#### ECN-GFC01:

First Page								
TITLE:	GliderFlightController							
Document Number: NA			REV: <b>1.1</b>					
Date: 5/	23/2023 9:03 PM	Sheet:	1/5

# 5V Servo Power Supply

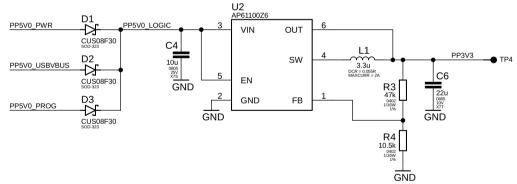
- Added PFET based reverse polarity protection on battery input.
  Added buck converter for 5V power rail from external battery.
  Added reverse protection for buck when externally powered from BEC.
  Removed boost converter.
  Changed USB ESD diodes to single array.
  Changed power LED color to green.
  Removed ESP32 DNI capacitor footprint.
  Added schematic annotations and design notes.
  Added test-points on power rails.

#### Design Note: Divider ensures 1.33V<EN<5.5V under all input voltages: VIN = 6V → EN = 1.55V VIN = 13V → EN = 3.37V
